BASEMENT PHOTOGRAPHS

Check all dimensions on site prior to commencement of work. Do not scale from this drawing except for planning purposes. This drawing is the © copyright of Jane Jones-Warner Associates This drawing has been produced for [Client Name] for the project [Project Name] and is submitted as part of the [Project Workstage] and is not intended for use by any other person or for any other purpose.	Revisions				JANE JONES-WARNER ASSOCIATES Unit 78 Chichester Enterprise Centre Terminus Road Chichester West Sussex PO19 8TX T : 01243 767151 E : mail@janejoneswarner.com W: www.janejoneswarner.com RIBA  Chartered Practice	Project: Magnolia House, Havant	
	Rev	Description	Date	Drawn		Drawing Title: Photographs of Basement (1)	
	-	-				Scale: NTS @ A3	Issue Date: 29/01/2020
						Drawing No: 692/PL 808	Revision: -
						Drawn By: MJ

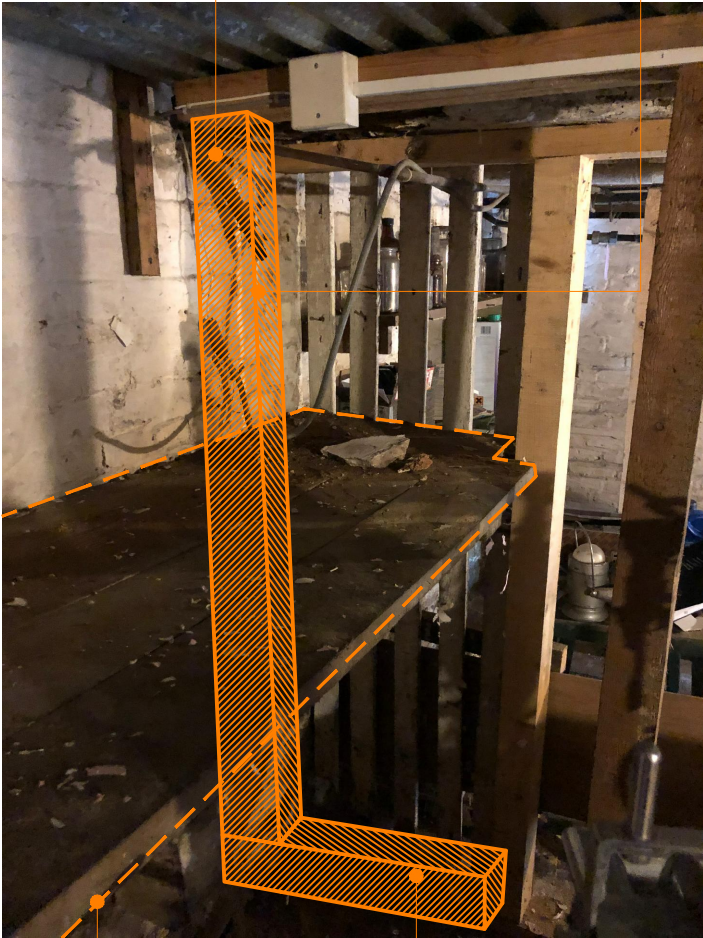
New timber post inserted at end of beam on account of decay found within the beam end

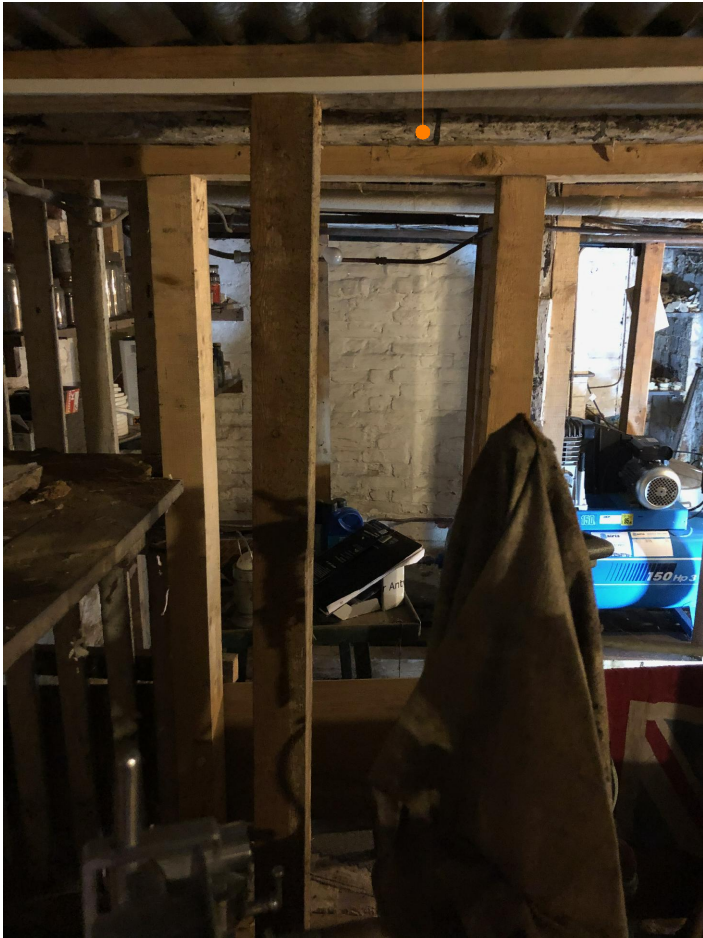
New post to be strapped to the beam in accordance with Structural Engineer's details. Folding wedges added under new timber post

Packers to be inserted beneath existing 'modern' joists to address movement under foot - see Structural Engineer's Detail E

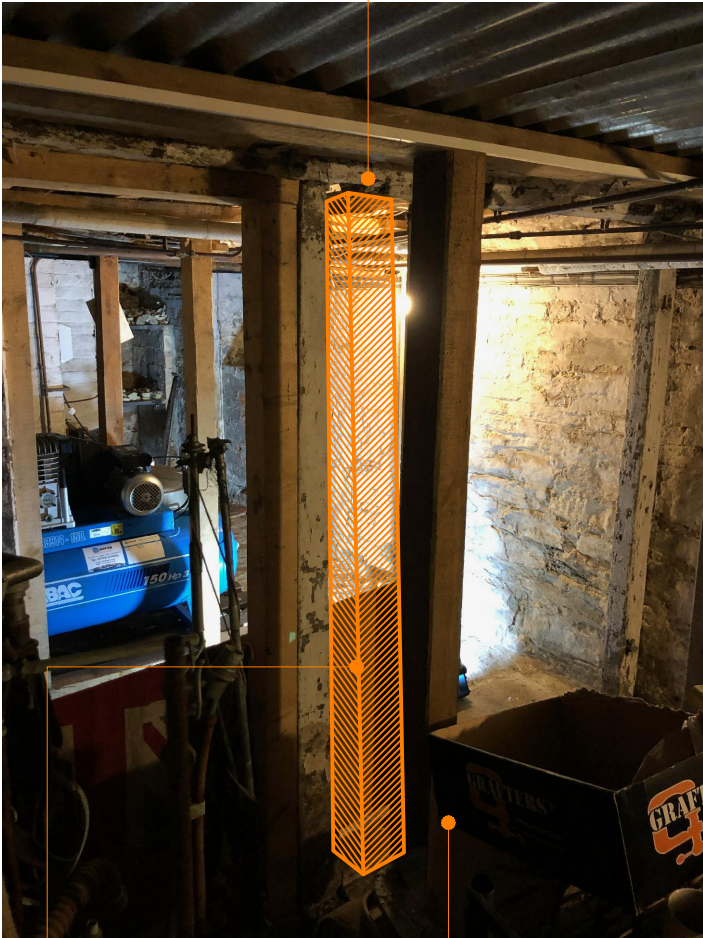
New timber post inserted to provide additional support to historic timber beam, all to Structural Engineer's Detail C

Shelves removed

Existing section of decayed timber wallplate to be replaced with a section of mortar bedded engineering bricks. DPC material to separate timber from masonry
